REVISED RESPONSE TO REQUEST FOR ADDITIONAL INFORMATION

APR1400 Design Certification

Docket No. 52-046

RAI No.: 506-8649
SRP Section: 10.03.06 – Steam and Feedwater System Materials
Application Section: 10.3.6
Date of RAI Issue: 07/26/2016

Figure 1 Piping layout in the OPR1000 design

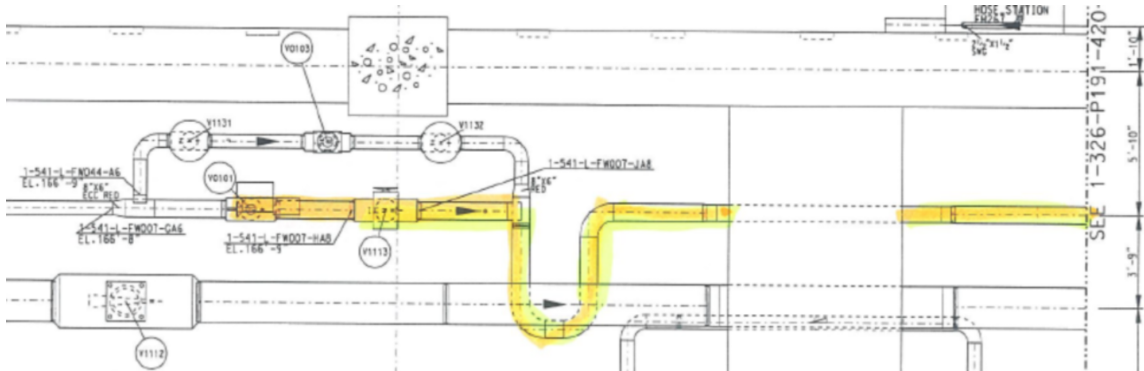
During the audit on May 10, 2016, the staff reviewed design documents for the feedwater system. While reviewing the design documents, the staff noted that a portion of downcommer feedwater line downstream of the downcommer flow control valve has a configuration of chrome-moly steel . carbon steel . chrome-moly steel. This configuration was not apparent to the staff prior to the audit.

- a. What material specifications are utilized for the carbon steel portion of the downcommer feedwater line between the chrome-moly portions of the same line (including the Main Feedwater Isolation Valves and connected safety-related piping)? This information should be added to DCD Tier 2, FSAR Chapter 10 or 6.
- b. Are the carbon steel portions of the downcommer feedwater line between the chrome-moly steel portions subject to augmented in-service inspection (ISI)? If augmented ISI will be performed on this section of piping, DCD Tier 2, FSAR Section 6.6 should be updated to state that these components are subject to augmented ISI and the augmented ISI should be described. If augmented ISI will not be performed, provide a justification on why additional ISI is not necessary considering that there may be an active degradation mechanism (FAC).

- a. In the OPR1000 design, chrome-moly steel is utilized between the MFCV and MSVH line, which contain sharp bending portions susceptible to FAC as shown in Figure 1. In the APR1400 design, carbon steel is utilized between the MFCV and MSVH line, which do not have sharp bending portions as shown in Figure 2. A 3D piping layout is presented in Figure 3 between the MFCV and MSVH line comparing the OPR1000 and APR1400 designs. Accordingly Table 10.3.2-4 will be revised.
